CASE NO. UDP-RS24007

CASE	UDP-RS24007
PROJECT NAME	450 Federal Signage
APPLICATION TYPE	Site Plan Level II Review: RAC Signage
APPROVAL LEVEL	Site Plan Level II, Subject to 15-Day Commission Request for Review
REQUEST	New Projecting Blade sign containing 4 tenant signs
APPLICANT	Gaddis Properties, LLC
AGENT	Denise Williams / Art Signs
PROPERTY ADDRESS	450 North Federal Highway
ABBREVIATED LEGAL DESCRIPTION	HOLMBERG & MC KEES SUB 1-112 D LOT 1 THRU 8 BLK 5 TOG WITH 10 FT VAC ALLEY PER INSTR# 116044223 LESS ST RD R/W
ZONING DISTRICT	Regional Activity Center – East Mixed Use (RAC-EMU)
LAND USE	Downtown Regional Activity Center
COMMISSION DISTRICT	2 – Steven Glassman
NEIGHBORHOOD ASSOCIATION	Victoria Park Civic Association
SUBMITTAL	February 25, 2025
COMPLETENESS ISSUED	March 17, 2025
EXPIRATION	July 15, 2025 (120 Days)
CASE PLANNER	Tyler Laforme, AICP Urban Planner III

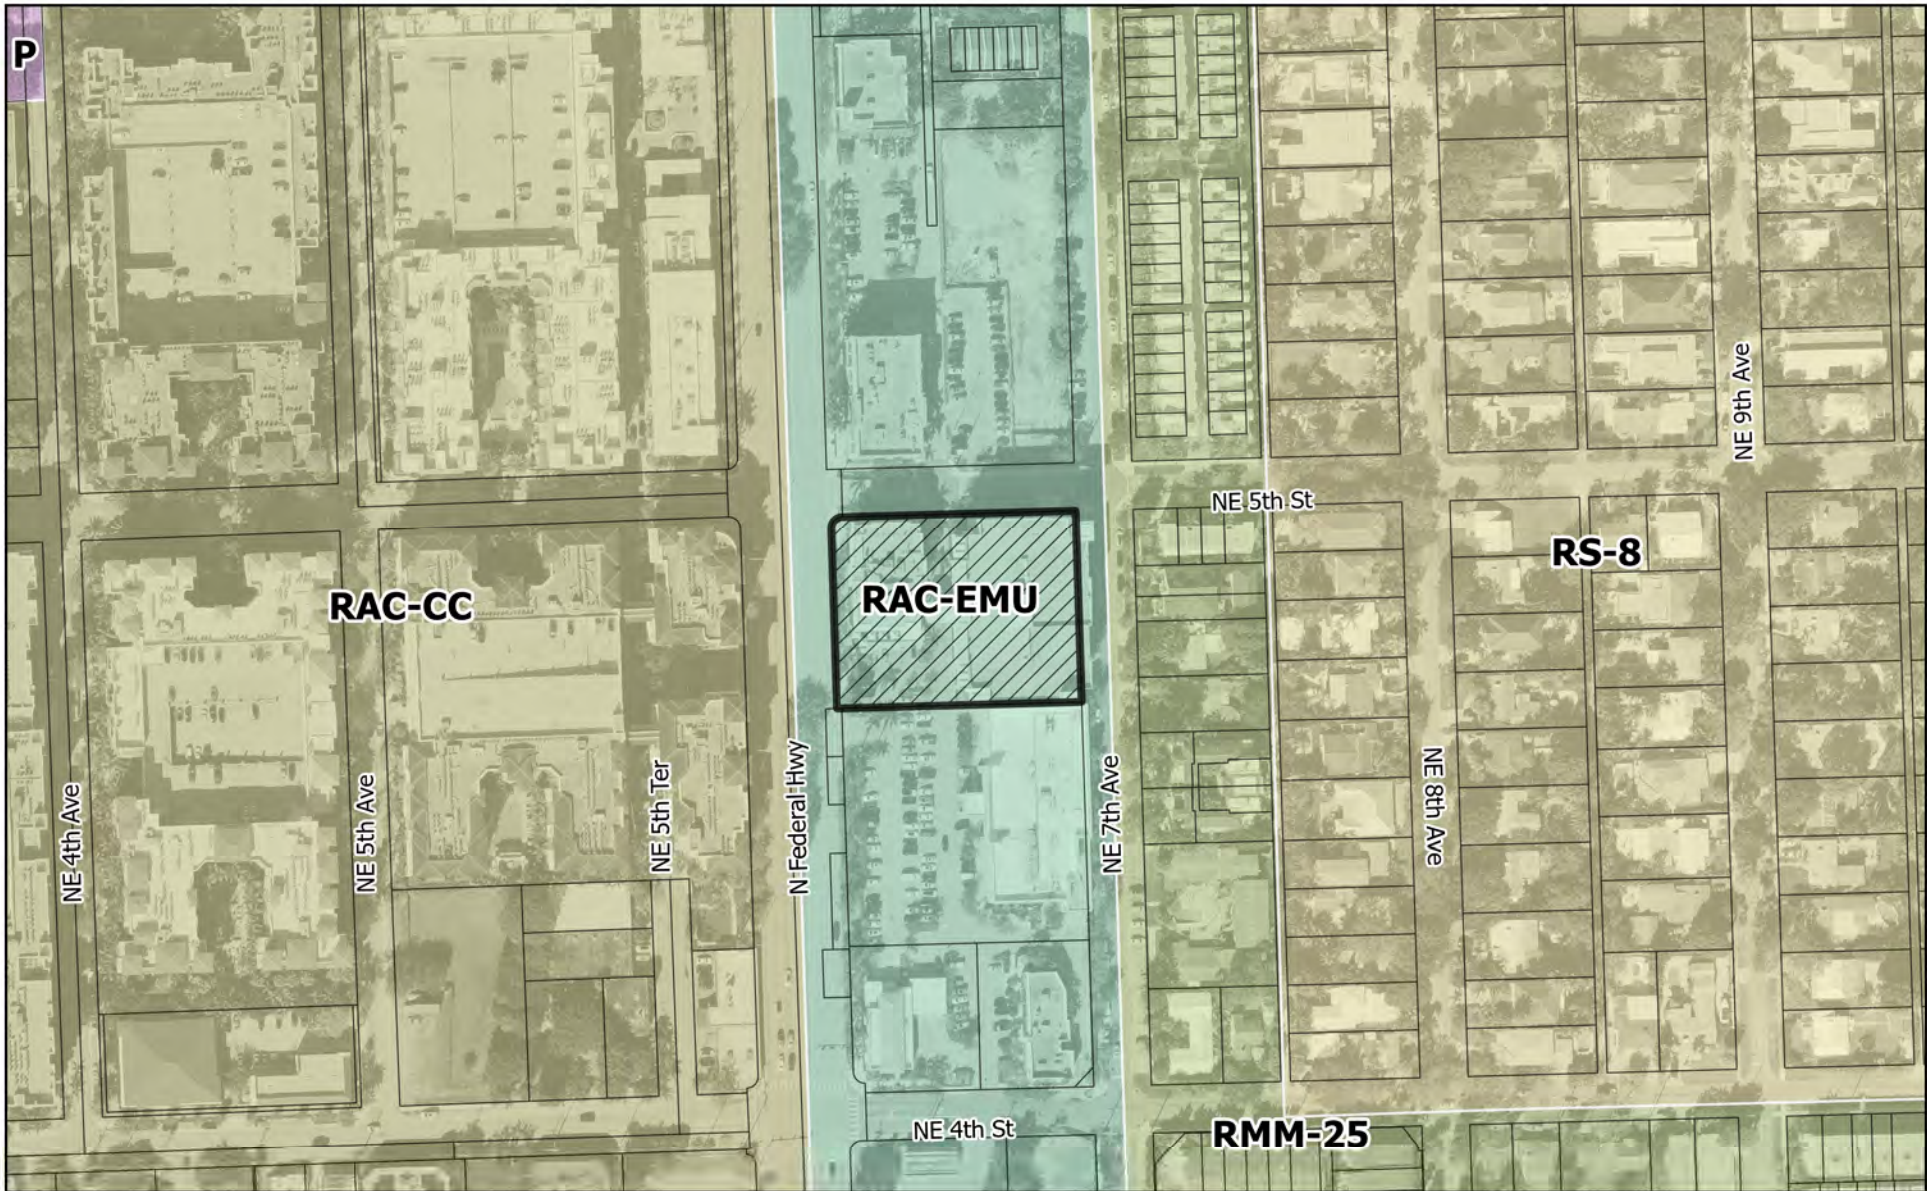
Proposed signage should align with the overall intent of the Downtown Master Plan and should not create clutter, impede the pedestrian environment, or create visual obstructions in the public realm. For the reasons stated herein, numerous small tenant signs on a single vertical blade sign is discouraged. Other solutions may be more appropriate and may be approved on a case-by-case basis. For example, horizontal blade signs, consistent in height and width, may provide great opportunities with clear visibility of a maximum of one business location at the pedestrian level, while not impeding the pedestrian experience itself.

Oversized signs, numerous small signs, signs containing a clutter of letters or messages, all compete for the public's attention and readability of the sign itself. Other common issues include quality of fabrication (materials such as plastic or vinyl are not high-quality materials), poor selection of typefaces and colors, illumination options, and placement, style, and sizing that bears no relation to the adjacent building's architecture.

Sign types and materials must be carefully selected to maintain durability and enhance the public realm throughout the Downtown. Respond to this comment by providing a written narrative outlining the design

approach used for the proposed signs consistent with the Downtown Master Plan overall vision, as stated in the comment above. Update narrative according to the following comments.
